Devon Energy Production Company L. P. respectfully requests to abandon existing Bone Spring & Delaware perms. Recomplete to Cherry Canyon as follows:

Well Name: RADAR 24 FEDERAL 1	Field: LUSK WEST
Location: 660' FNL & 1980' FWL: SEC 24-T19S-R31E	County: EDDY State: NM
Elevation: 3558' KB: 3540' GL: 18' KB to GL	Spud Date: 10/4/00 Compl Date: 1/25/01
AP#: 30-015-31357 Prepared by: Ronnie Slack	Date: 10/22/13 Rev:

**Radar 24 Fed 1
30-015-31357
Devon Energy Production Co.
December 11, 2013
Conditions of Approval**

CURRENT SCHEMAT

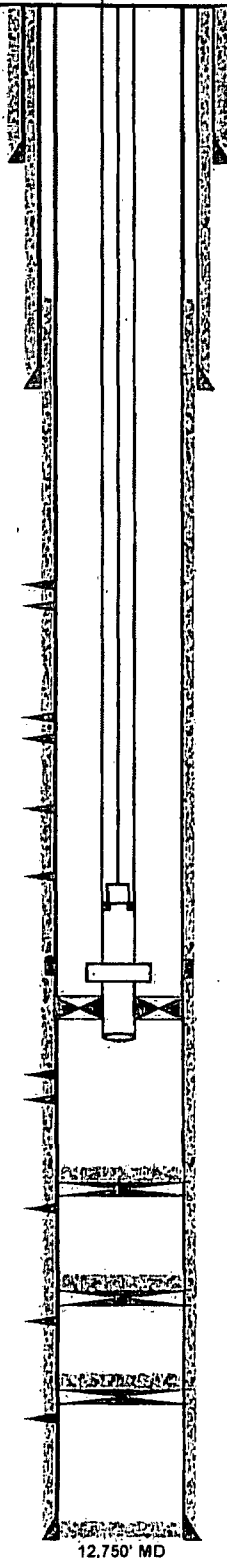
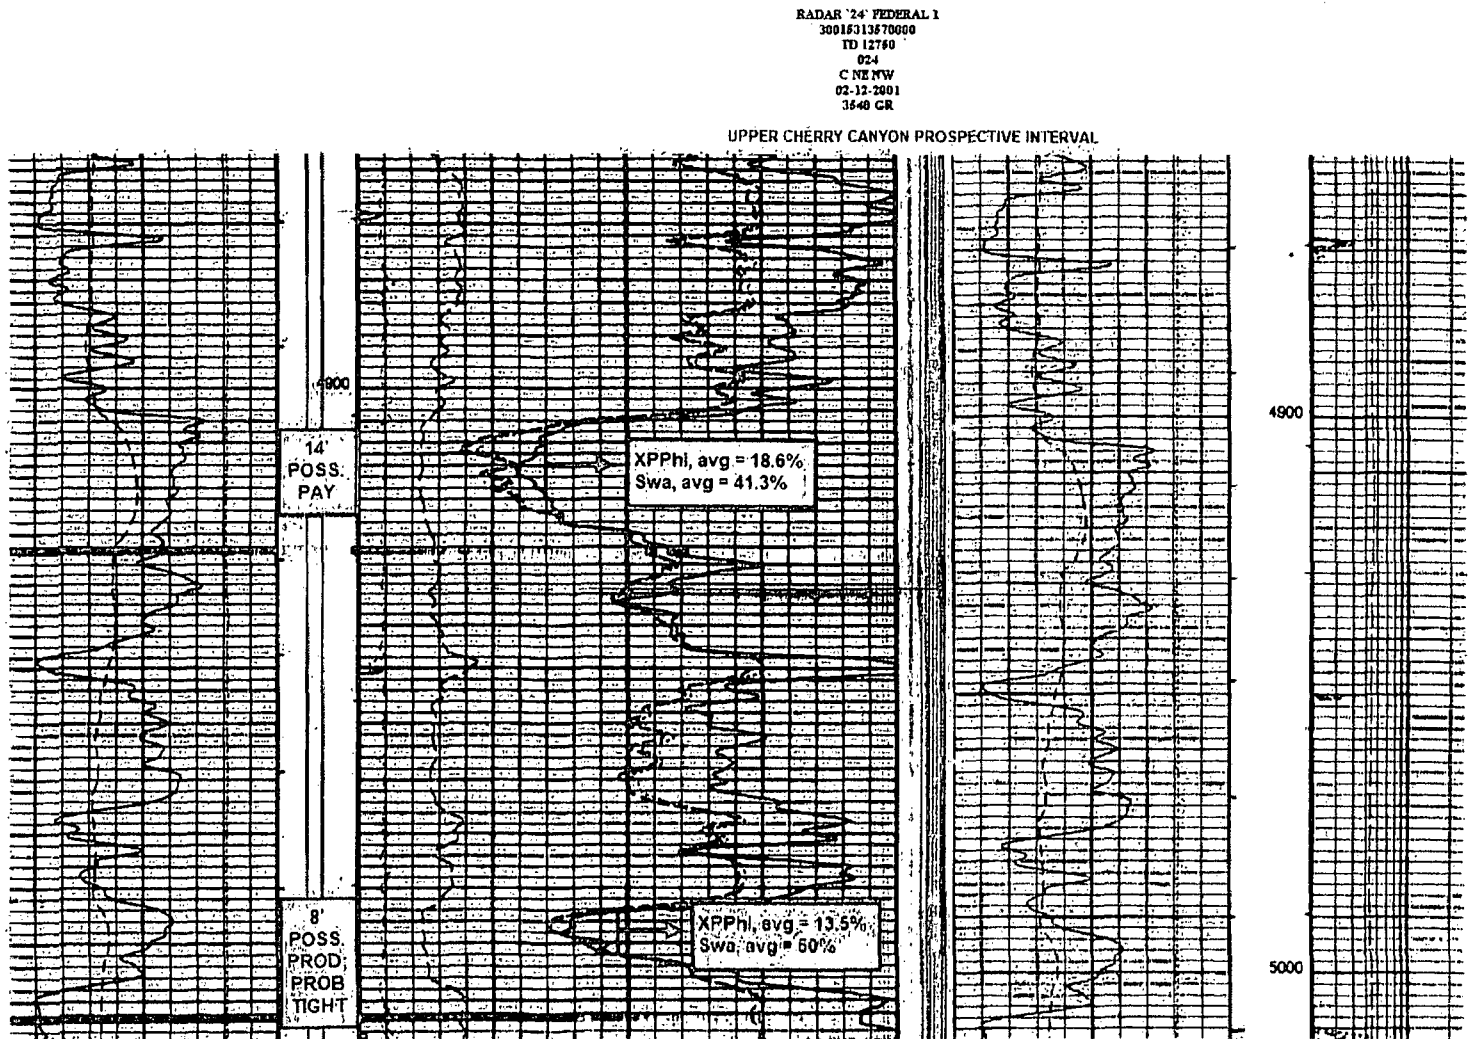
- 1. Drill out CIBP at 9850' and spot a 205' plug must be set across the top of the Wolfcamp from 10,530'-10,325'.**
- 2. Set CIBP at 9600' and pump 35 sx of class H cement as proposed. Tag at 9400' or higher.**
- 3. Set CIBP at 7215' and spot 225' of class C cement to 6990'. (Bone Spring Top 7040').**
- 4. Set CIBP at 5250' and pump a minimum of 25 sx or bail 35' class C cement on top.**
- 5. Surface disturbance beyond the originally approved pad must have prior approval.**
- 6. Closed loop system required.**
- 7. Operator to have H2S monitoring equipment on location as H2S has been reported from wells in the area.**
- 8. Subsequent sundry, completion report and wellbore schematic required.**
- 9. See attached general plugback requirements.**
